Staff Report to the Zoning Administrator

Application Number: **10-0038**

Project Description: Proposal to recognize construction of a 4,113 square foot, 2-story single-family dwelling, 996 square foot second unit, 1,875 square foot horse shelter, pond, and grading of approximately 210 cubic yards. Proposal also includes development of a family-operated winery producing more than 1,000 gallons annually.

Grading and Drainage Plan
Paisley Residence
R.N. 85-301-01

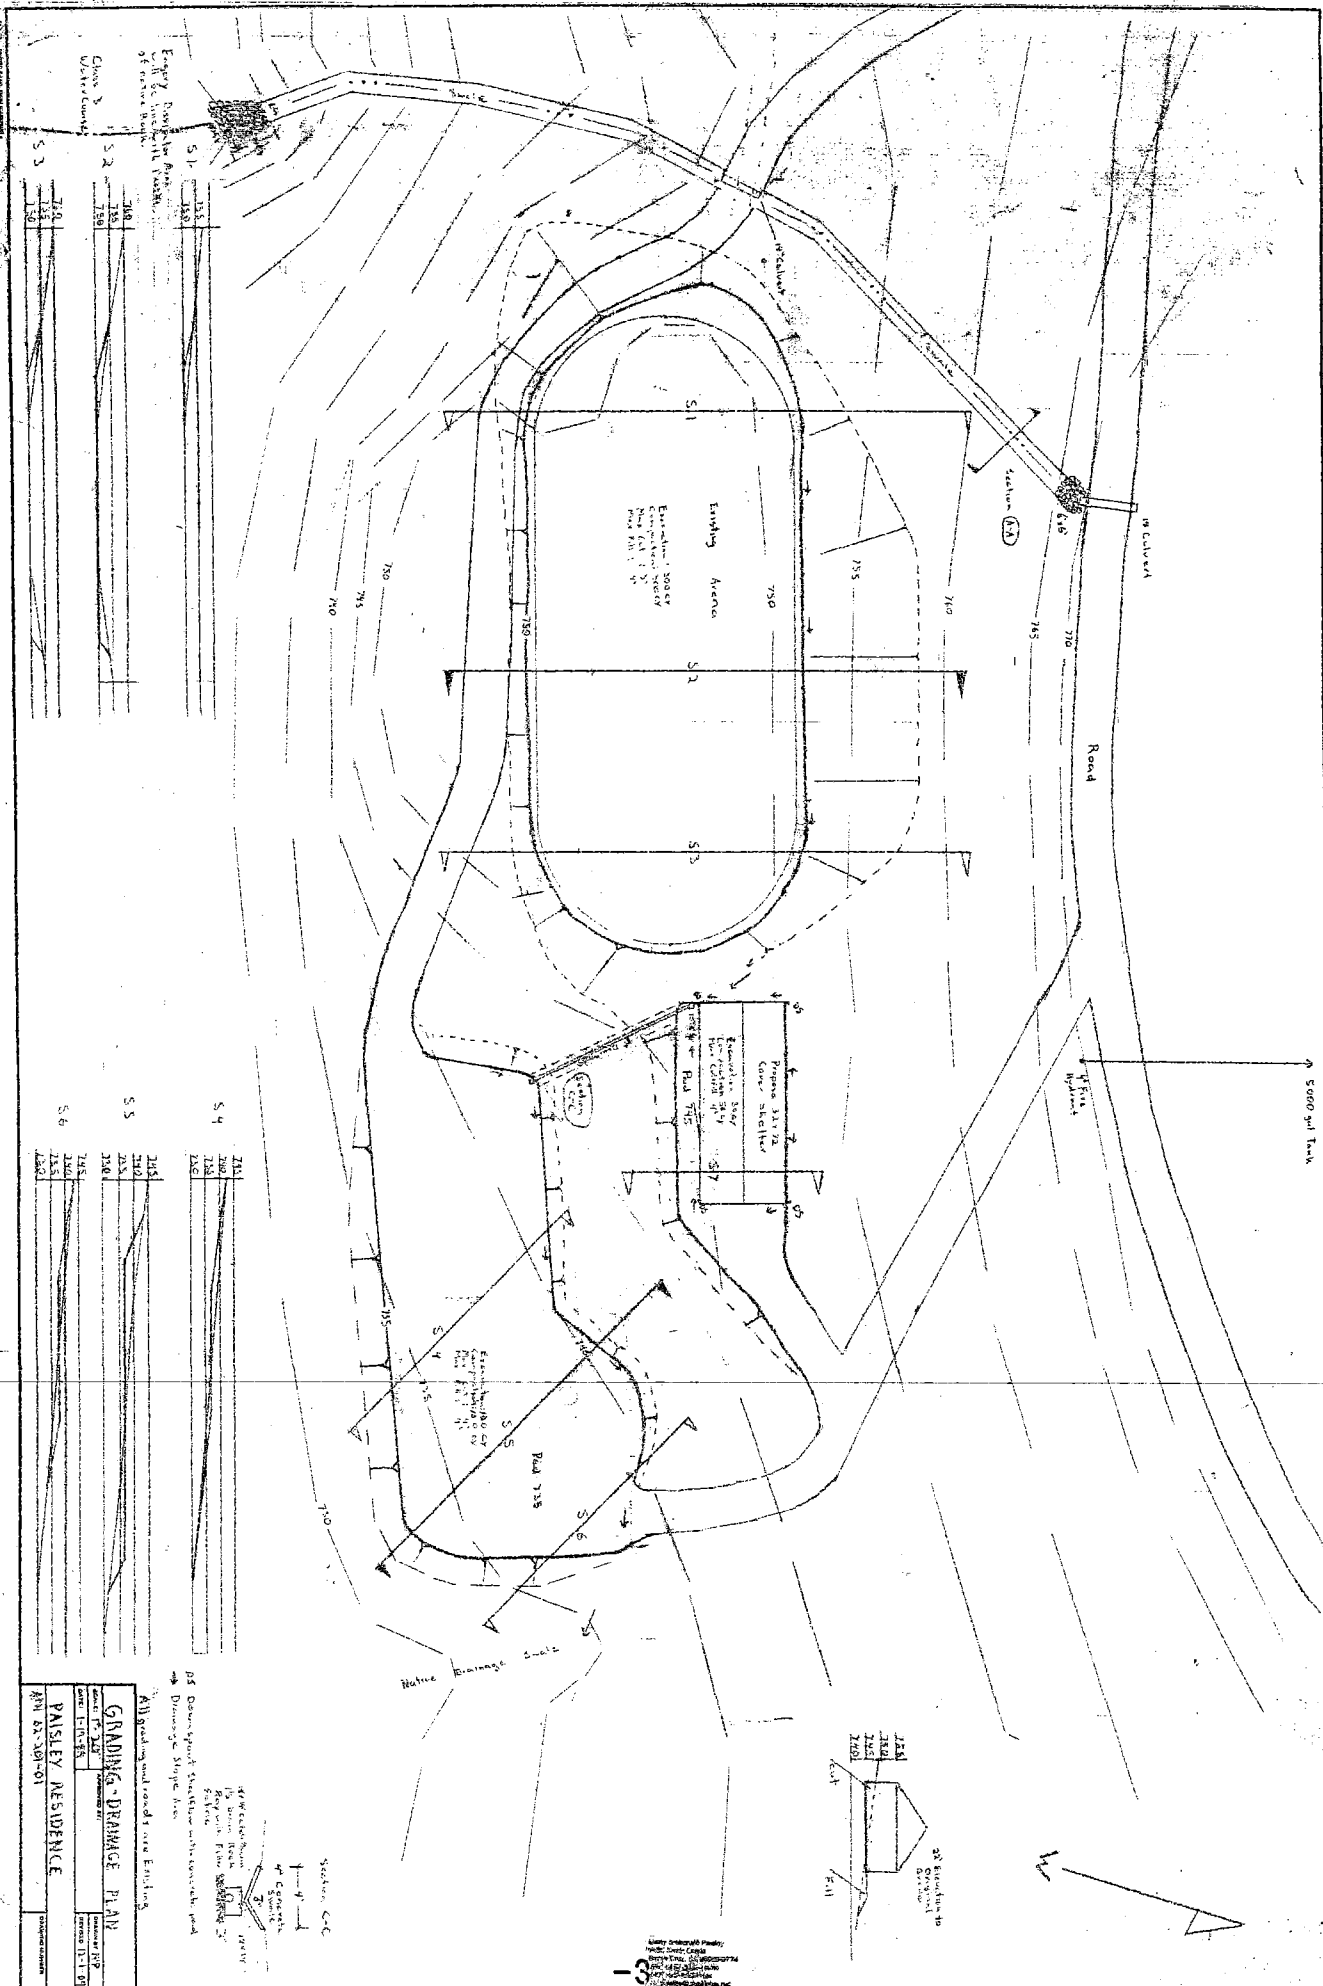
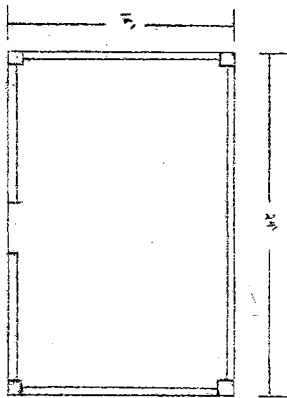
The profile on sheet C-1 is from a grading alignment taken through the proposed pond embankment and road fill prism labeled and is section F-F. The profile shows the proposed improvements for two areas; the pond embankment and the road fill prism. For each of the two improvement areas, compacted fill is shown buttressing the existing slopes. The buttresses are shown to have a key as recommended by the Geotechnical Engineer; however the key shown does not meet the Geotechnical recommendation of having a depth of 3 feet. The Geotechnical Engineering Report recommends a key width of 1.5 times the equipment width. The key shown in the profile is approximately 1.5 feet and will meet the requirements if the equipment used has a 12 inches wide bucket. The Geotechnical Engineering Report requires the addition of a sub-drain at the back of the keyway which should consist of a perforated 4 inch diameter pipe encapsulated in crushed rock and geo-filter fabric. The sub-drain and its components are missing from the plan set.

The improved slopes on the grading profile are called out as 2H:1V slopes, though graphically the improved road prism embankment slopes are shown as 1.41H:1V, based on the designated scale of $\frac{1}{4}'' = 1'$. A note on sheet C-1 indicates that the maximum fill height is 8 feet, and the scaled profile shows the fill heights for the pond buttress and the road fill buttress to be 6.5 feet and 6 feet, respectively. The resulting access road is 18 feet wide and will have an inboard slope directing the road runoff towards the toe of the pond embankment buttress and away from

In plan view, the proposed improvements are shown using slope lines and slope arrows to indicate the toe of the buttress slope. The slopes are called out as "2 to 1", meaning 2H:1V. A dashed line is used to show the limit of grading for the slope buttressing. The contours on the plan are shown as extending approximately 40 feet beyond the limit of grading, 10 feet less than required by the County of Santa Cruz planning staff.

It appears the applicant has chosen to buttress the unengineered pond embankment with a 2:1 slope and widen the roadway, necessitating the installation of a second 2:1 slope downslope of the driveway. The applicant prepared hand drawn plans showing the general location of the proposed improvements which were summarized in the submitted memo from Fall Creek Engineering.

Our previous comments requested "preparation of a grading and drainage plan by a civil engineer" and that the plan be based on "a surveyed topographic map of the area, with data extending 50-feet beyond the limits of grading or to the toe of slope below the driveway, whichever is greater". Neither of these requirements have been met with the submitted documents. The grading plan was not prepared by a registered civil engineer, the topographic data is of unknown origin and does not extend to the toe of slope below the driveway. The review letter from the civil engineer simply stated what improvements were shown on the plans and noted several inaccuracies, and does not act as a substitute for civil engineered grading and drainage plans.
